# Franklin Township

## Township Technical Review Committee (TRC)

### MEMORANDUM

Re: Sharonda Copeland – Backyard Pool - “C” Variances (ZBA-21-00004)  
14 Larsen Road (Block 399, Lot 19)

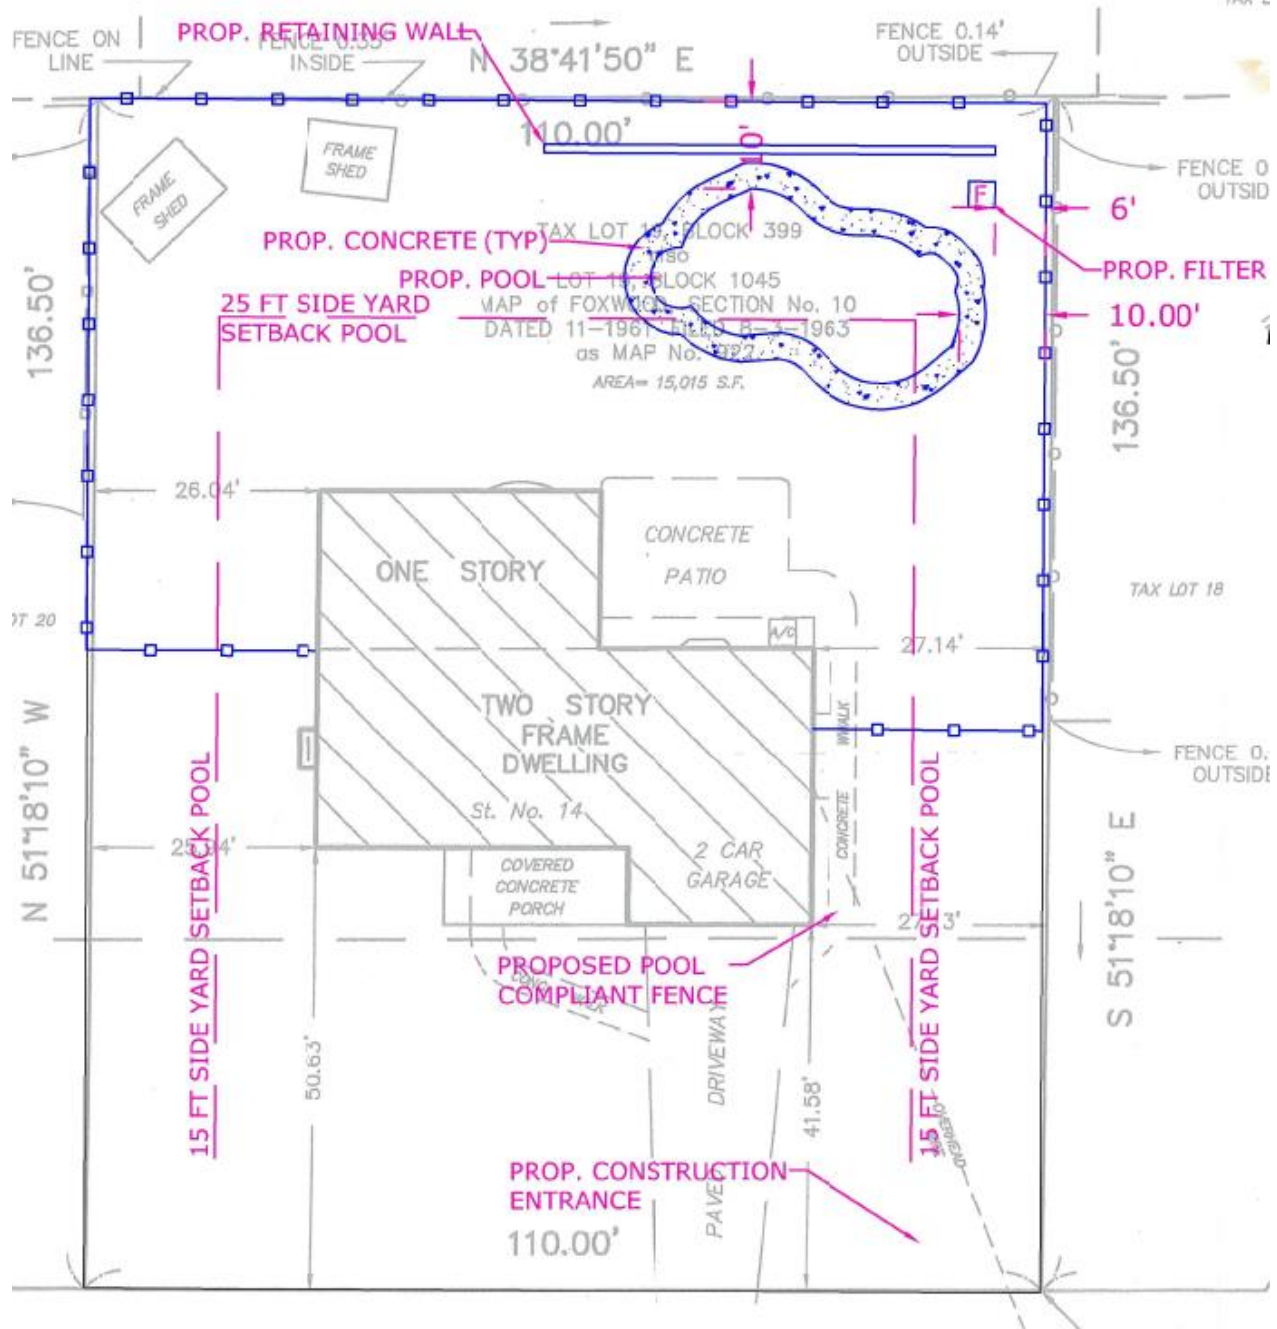
- *Side Yard Setback*: 15 feet required – 10 feet proposed
- *Rear Yard Setback*: 25 feet required – 10 feet proposed
- *Impervious Coverage*: 25% permitted – 27.48% proposed

1. If the applicant seeks to address this as a hardship (i.e., a C-1 variance) then they should address why the pool couldn’t be placed in a compliant or more-compliant location.

Alternatively, the applicant will need to prove that the proposed location would represent a better zoning alternative than compliant placement of the pool such that the purposes of the Municipal Land Use Law (MLUL) would be advanced (i.e., a C-2 variance).

2. It is noted that 3 of the 5 properties that adjoin the subject lot also have in-ground pools. It would appear that the pools on the properties to the north of the site have pools located *roughly* 15 feet from their property line and *roughly* between 10-15 feet from the nearest side property line. It would appear that the pool on the property adjoining to the rear of the subject site is in a compliant location (25 feet rear/ 15 foot side).

3. As the site proposes additional impervious and proposes more than 2,500 square feet of disturbance Chapter 330, Stormwater Management, of the Township ordinance will apply. The application will be reviewed for consistency at the time of building permit submittal. Such review will include the design/ placement of the retaining wall and potential means to prevent ponding behind the wall.

4. The plan shows placement of a fence on the neighboring property to the south (left on the plan). This will need to be corrected on the plan prior to issuance of the zoning permit for the proposal.
